General SPD EIS and NEPA Process

Re: Comment on the Surplus Plutonium Disposition (SPD) Draft Environmental Impact Statement (EIS)

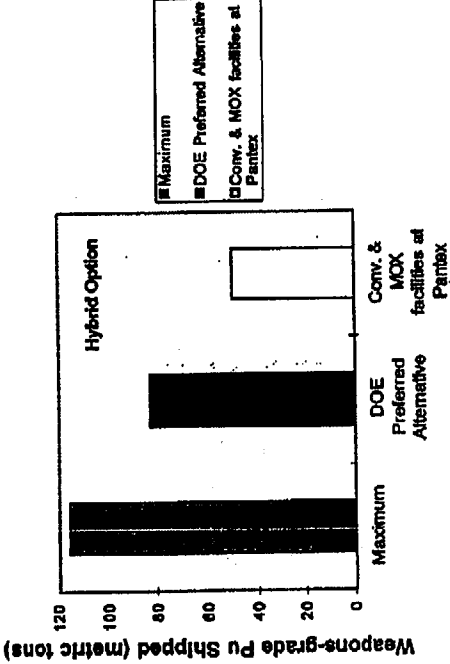
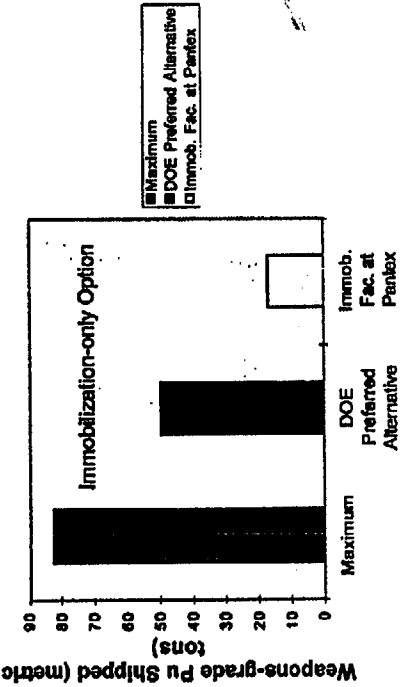
- Summary: If proliferation concerns associated with shipment of these materials is so great that a reduction of 33 1/3 in the amount to be shipped is sufficient to cause an otherwise reasonable alternative to be deemed unreasonable, then why is there no record that those alternatives leading to similar further reductions were given commensurate credit?

- The following bar charts are an effort to present this graphically. DOE deems the shipping reductions in going from the left bars to the middle bars as sufficient to make alternatives requiring the maximum shipment unreasonable, on the basis of the associated proliferation risk. But there is no evidence I can find that they value the equivalent further reduction in going from the middle to the right bars - which just happen to favor Ponce - as worth a tinkers dam.

DOE acknowledges the commentor's preference for Alternatives 9 or 10, which involve collocating pit conversion and MOX facilities at Pantex. The location of the immobilization facility was considered in the *Storage and Disposition PEIS*, and the ROD states DOE's strategy to immobilize at either Hanford or SRS. Therefore, this SPD EIS does not analyze immobilization at Pantex. Table L-6 shows the total transportation risks for all alternatives, including Alternatives 9 and 10. The transportation impacts for the preferred alternative, Alternative 3, are similar to Alternatives 9 and 10.
